Response to Comment C35-58 (continued)

Letter - C35

FIGURE C3.1-2

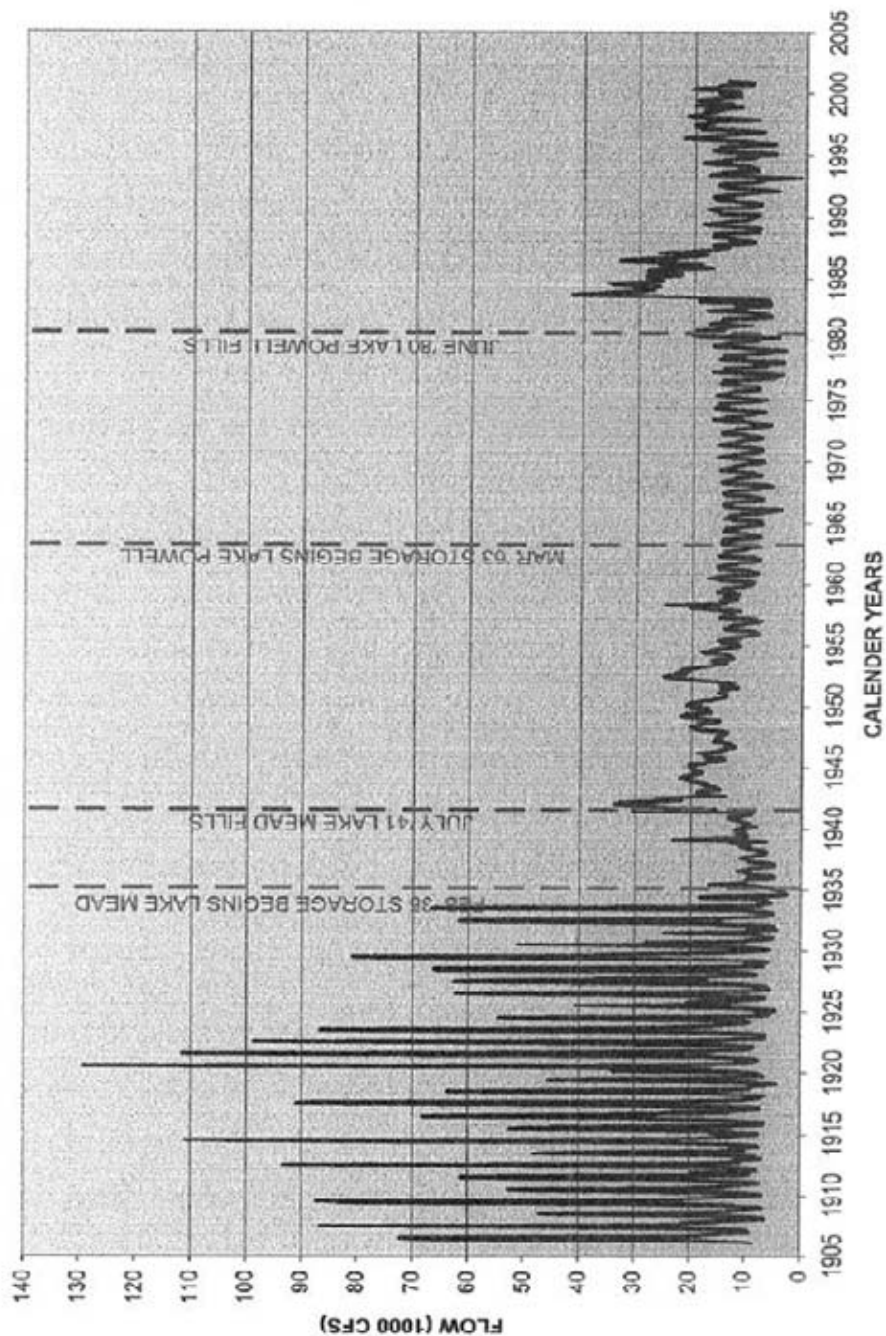
Even with the IOP and IA in place, many factors impact the amount of water released from Parker Dam, including crops, cropping patterns, and weather. With regard to the 1983-1986 flows being an aberration, even if the 1983-1986 flows are excluded from the calculation as the commenter suggests, the range of flows for the remaining years (1980-2001) is 5,189 KAF with an average of 7,633 KAF. Even with this reduced average, river flow changes for the IOP and IA fall well within the historical range of operations. If only the last seven years are used, 1995-2001, the range of annual flows is 3,661 KAF with an average of 8,117 KAF.
